Planning & Building Services Department
Heritage & Urban Design (HUD)

Memo To: Ferdi Toniolo, Senior Planner
From: Kunal Chaudhry, Senior Urban Designer
Subject: **Official Plan Amendment / Zoning By-Law Amendment**

Applicant Name: Collecdev Inc
Municipal Address: 8868 Yonge Street
Legal Description: Part of Lot 38 Concession 1
City File No.: 23-0006, ZBLA-23-0010

Fig.1.0

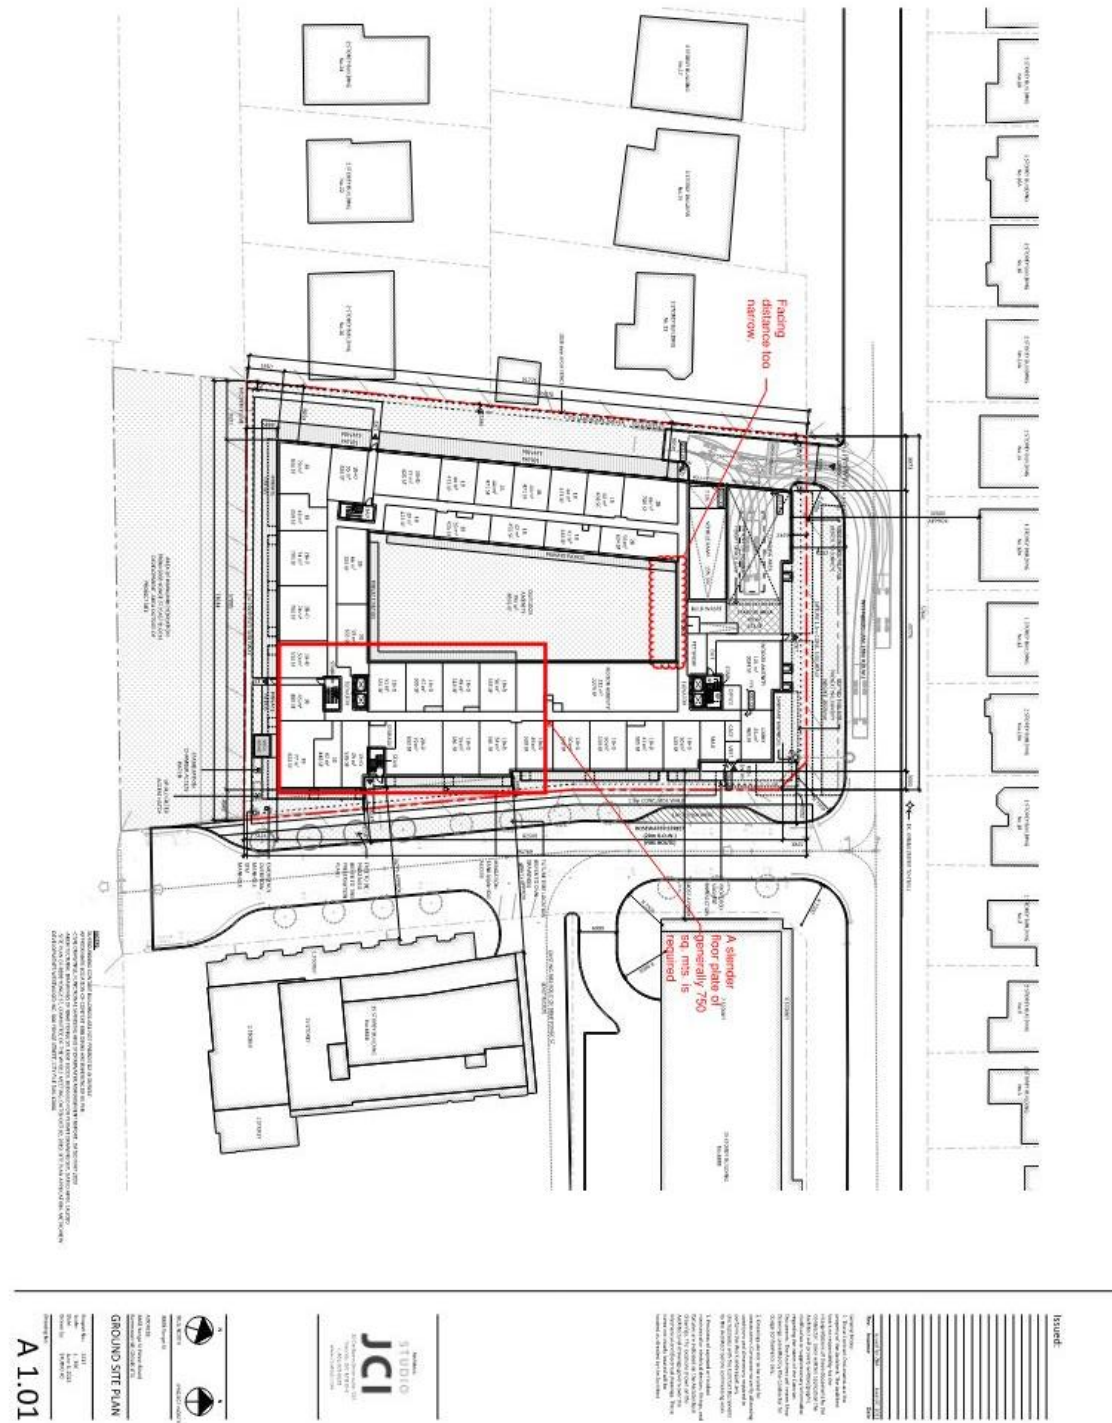
Issue	HUD Staff Comments	Reference
1. Facing Distances	Urban Design staff protect for 25 metres separation distances between high-rise built forms, and 15 metre facing distances for townhouse built forms. To that effect, a facing distance/building separation of 20 metres needs to be provided for between high-rise and mid-rise built form. Staff find that the width of the courtyard at the narrowest point in the northern portion is too narrow to accommodate an appropriate facing distance between a high-rise and mid-rise built components of the proposed built form. Please refer to Fig 1.0 below.	OP 3.4.1.57 UDG 6.4.22

2. Base Building Height	Further to point C.1 above, a base building ranging from 3 to 6 storeys shall be considered.	RHSP 10.3.2.2
3. Location of Tower Built Form	Further to points B.1 and C.1, the applicant should consider a slender tower located, at the south-east corner to ensure facing distance and floor plate requirements are met. Refer to Figures 1.0 and 2.0 below.	<p>OP 3.4.1.57 OP 3.4.1.58 UDG 6.4.22</p>
